Product Change Notification: SYST-17ZCED145

PIC18F27/47/57Q84 Silicon Errata and Data Sheet Clarifications

Description of Change:

Added silicon issues 1.1.6, 1.2.2 through 1.2.8, 1.11.1, 1.12.1, 1.13.1, 1.14.1 and 1.15.1; added DS Clarifications 2.1 through 2.13.

1.6.1. UART TXDE Signal May Go Low Before the STOP Bit Has Been Entirely Transmitted

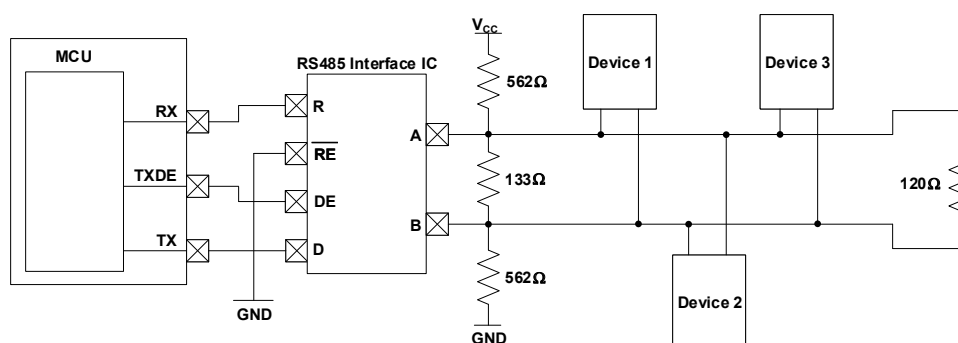
The UART Transmit Drive Enable (TXDE) signal could potentially transition into a low state before the UART Stop bit has been entirely transmitted due to the effects of parasitic capacitance on the TX line. In some applications, this could result in communication being prematurely terminated due to the TXDE signal going low before the STOP bit has had enough time to settle.

To ensure that the Stop bit settles into its final logic state before the TXDE signal transitions low, a biasing circuit can be implemented. A biasing circuit allows the TX line to either be driven high or low, rather than being left in a floating tri-state mode, where prolonged rise or fall times could lead to communication being disrupted. This bias circuit must only be implemented on one end of the serial bus, and a termination resistor must be used on the other end. The figure below shows an example of a bias circuit that can be used to achieve this.

Please note that the resistor values used in this circuit are recommendations and that the actual resistor values required may vary based on the application.

2.6. 48-Lead TQFP Package Drawing

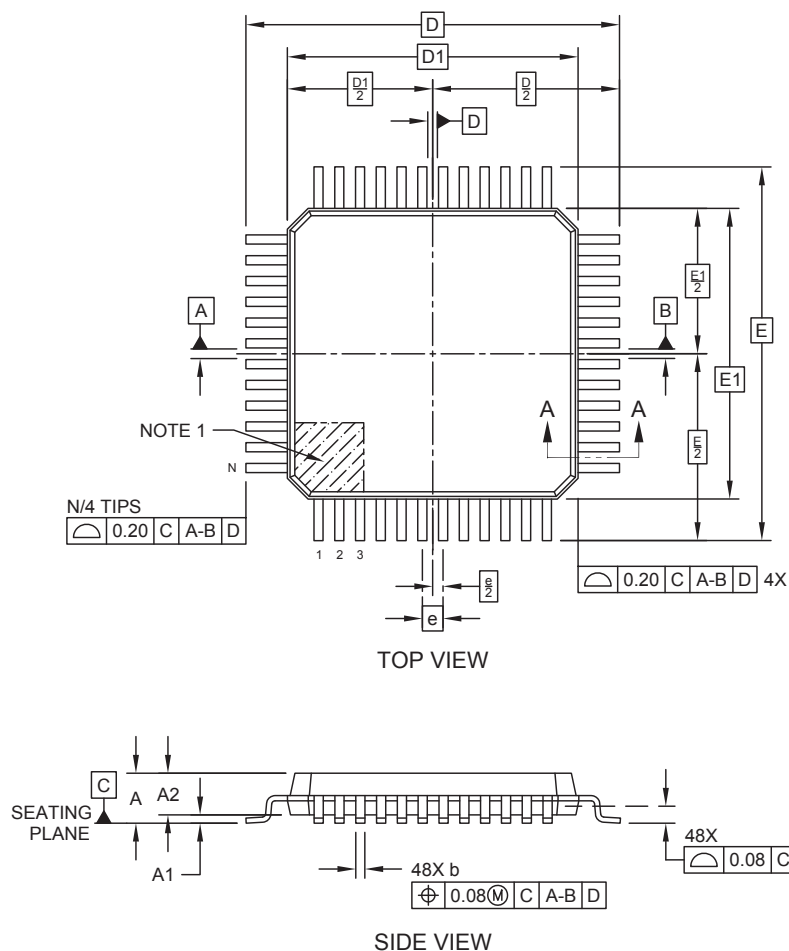
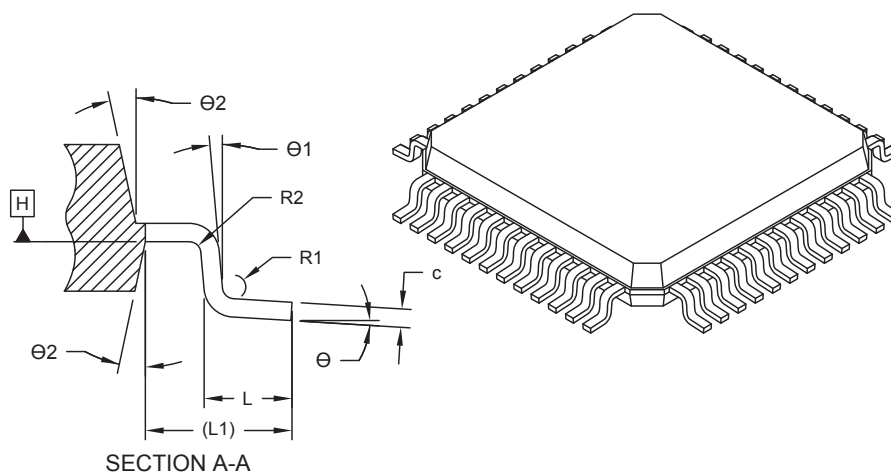
The data sheet lists the incorrect package drawing for the 48-lead TQFP package. The correct package drawings are shown below:

48-Lead Plastic Thin Quad Flatpack (Y8X) - 7x7x1.0 mm Body [TQFP]

Microchip Technology Drawing C04-300-Y8X Rev D Sheet 1 of 2

Microchip Technology Drawing C04-300-Y8X Rev D Sheet 2 of 2
